service bulletin

No. 96-16

Hurth V-Drive Output Flange Torque

73013

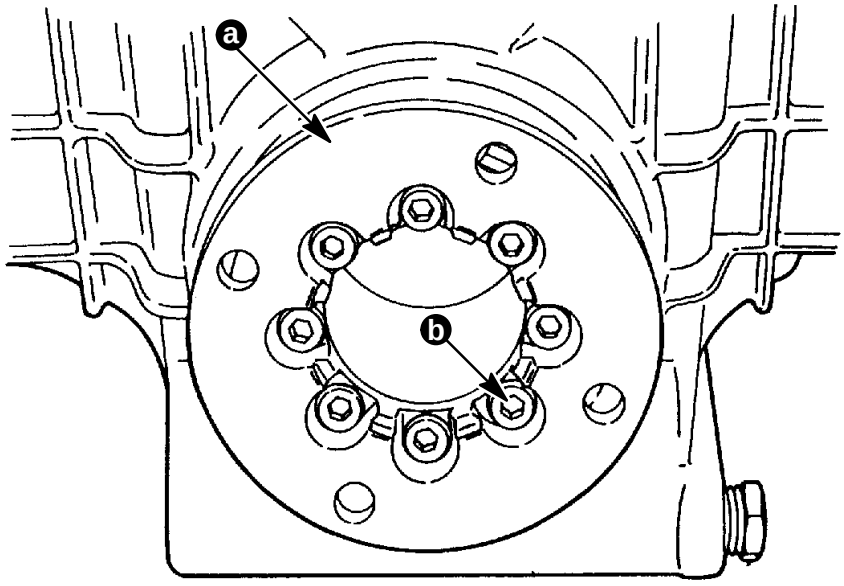
The output flange torque figures listed in #12,#15,#16, #19 and #21 Service Manuals are incorrect. The torque for the output flange is **listed** as 14 lb. ft. (18 N.m).

The output flange should be installed on the output shaft. Apply Loctite Type A to the threads of the bolts and **torque to 28 lb. ft. (36 N.m)**.
